File No.: 04-1000-20-2020-062

Equivalency reports or alternative solutions related to 1055 Dunsmuir Street, from January 1, 1981 to December 31, 1994.

RE: Interconnected Floor Space
10th and 11th Floors
1055 Dunsmuir Street

RE: OPEN STAIR
TOWER IV BENTALL CENTRE
FLOORS 24 and 25
1055 DUNSMUIR STREET

SECTION THRU 1HR RATED FIRE PARTITION

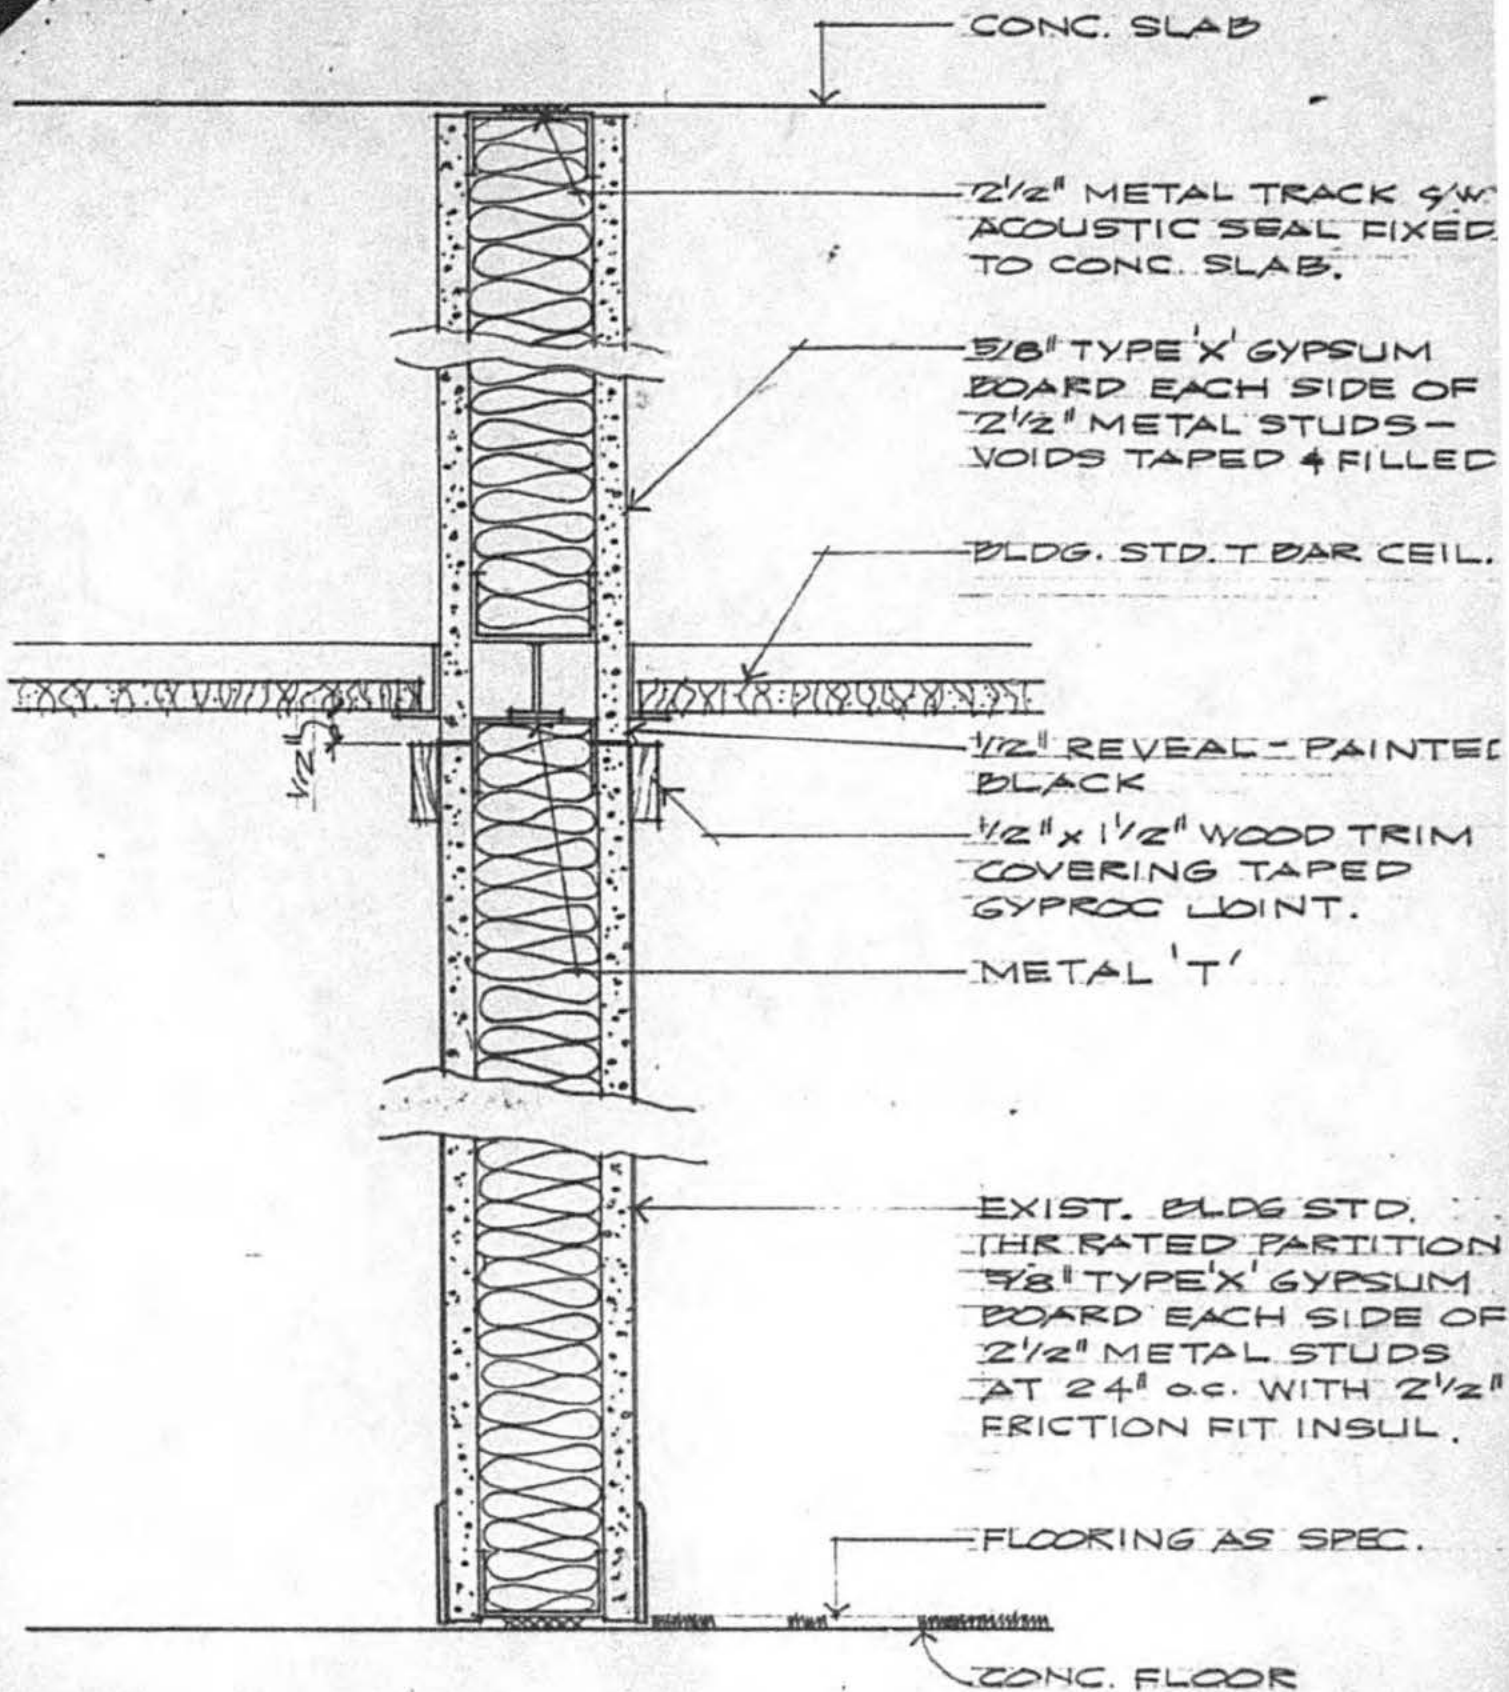
Re: Upgrading Fire Fated Walls To Underside of Slab
to Comply With Building Permit Plans

In response to your reply to our January 13th, 1983 letter re: the above subject, we are submitting herewith an alternate approach to upgrading those existing building standard corridor partitions requiring improvement in order to obtain approval for occupancy permits.

Would you please indicate your approval of this detail, by signing and returning one copy of our sketch, so that we may proceed with these corrections.

2nd Feb 83
Noted & approved.
Return one
City Interiors
